Re: Submission to proposed Smithfield Materials Recycling Facility at 132-144 Warren Road, Smithfield (SSD-19425495)

Re: 132-144 Warren Road, Smithfield – Proposed Smithfield Recycle Centre
Application No. SSD-19425495
TRAFFIX Peer Review

POLYTRADE SMITHFIELD RECYCLING CENTRE

FIRE SAFETY SCOPE REVIEW

Figure 4 – Extract from Fire Services Plan Drawings – Approach to Achieving Fire Hydrant Coverage.

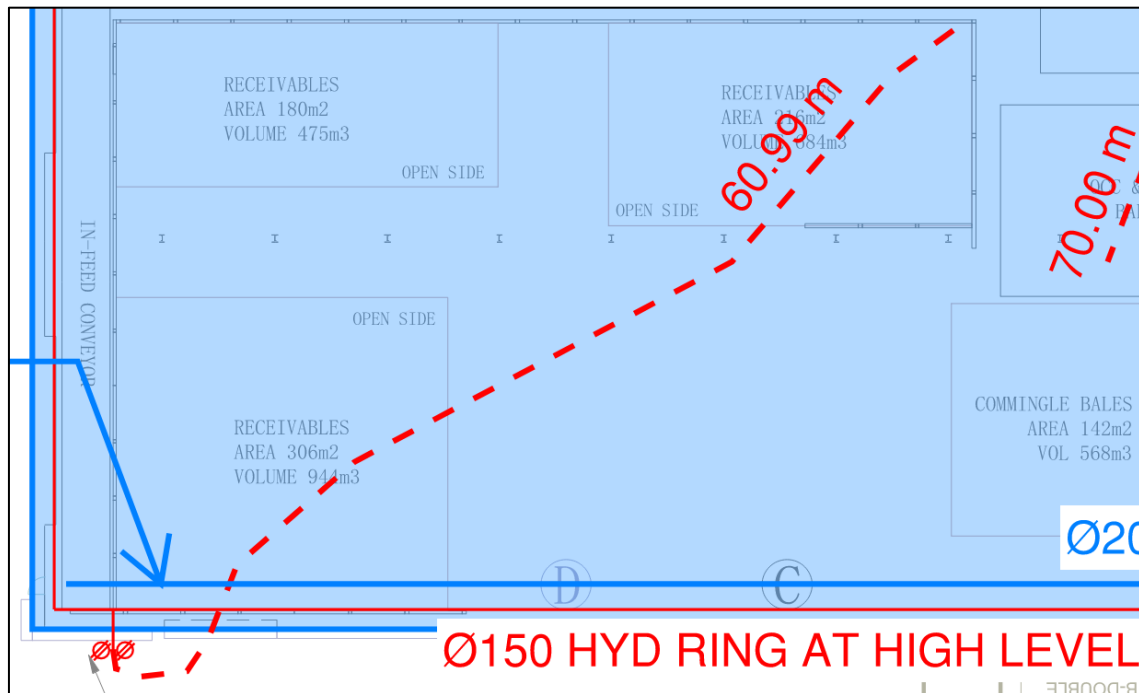
The Fire Services Plan drawing indicates fire hydrant coverage is achieved. However, coverage markups indicate the assumption that firefighters can carry their hose through roller doors and storage piles. As roller doors may be closed or storage piles may be full, fire hydrant coverage must be assessed based on using perimeter personnel access doors and treating storage pile zones as obstructions. Additional fire hydrants may be required to be included in the design as a result.

2.6	The Fire Services Plan drawing indicates fire hydrant coverage is achieved. However, coverage markups indicate the assumption that firefighters can carry their hose through roller doors and storage piles. As roller doors may be closed or storage piles may be full, fire hydrant coverage must be assessed based on using perimeter personnel access doors and treating storage pile zones as obstructions. Additional fire hydrants may be required to be included in the design as a result.

Figure 7 – Extract from Fire Services Plan Drawings – Fire Water Infrastructure Schematic.

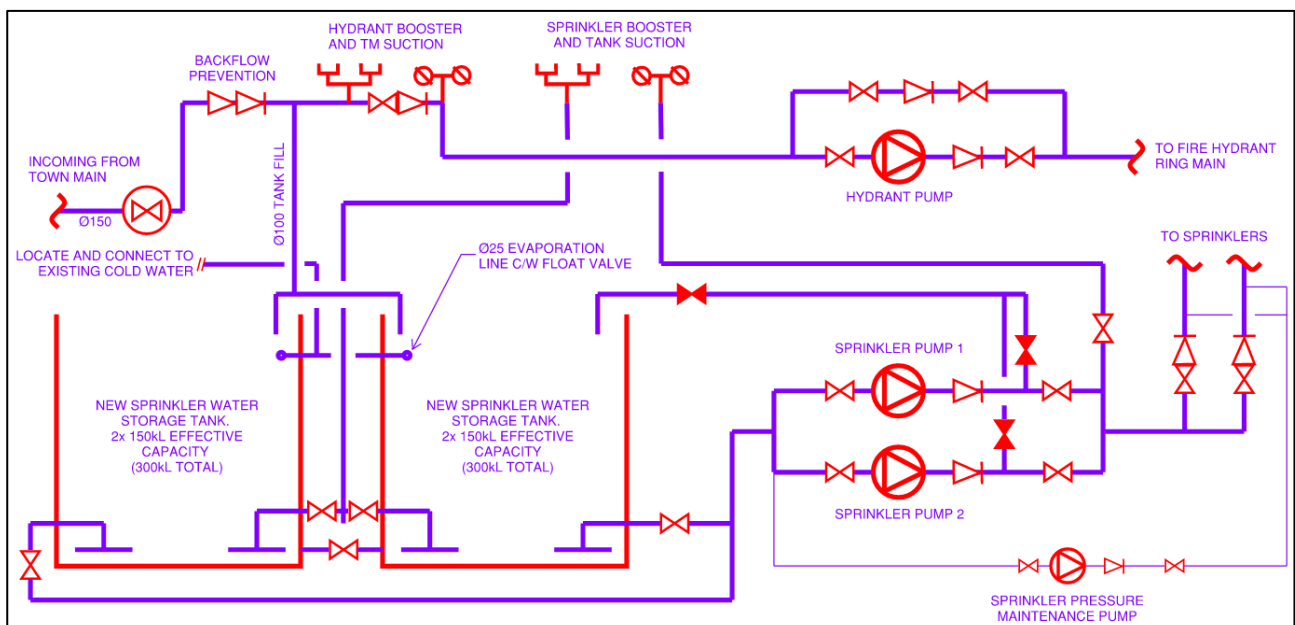
The storage arrangement is proposed to include baled and stockpile storage areas up to 4 m in height and 1,000 m³ in volume. This is considered outside of the scope of a High Hazard process occupancy as the storage is not considered *small, scattered amounts of in-process storage*. The design has instead adopted a High Hazard process risk occupancy designation.

The High Hazard storage design criteria is expected to result in a required increase to the effective capacity of the fire water storage tanks. As per Section 7.6.6 of the FRNSW Fire Safety in Waste Facilities Guideline, the fire sprinkler system shall have a minimum water supply and capacity providing the maximum hydraulic demand (i.e. flow rate) for not less than 2 hours (exceeding the requirements of AS 2118.1:2017).

Any increases to the effective capacity of the fire water storage tanks shall also be incorporated in the sizing of the stormwater containment system, which shall be sized to accommodate 2 hours of fire sprinkler flow and 4 hours of fire hydrant system flow.
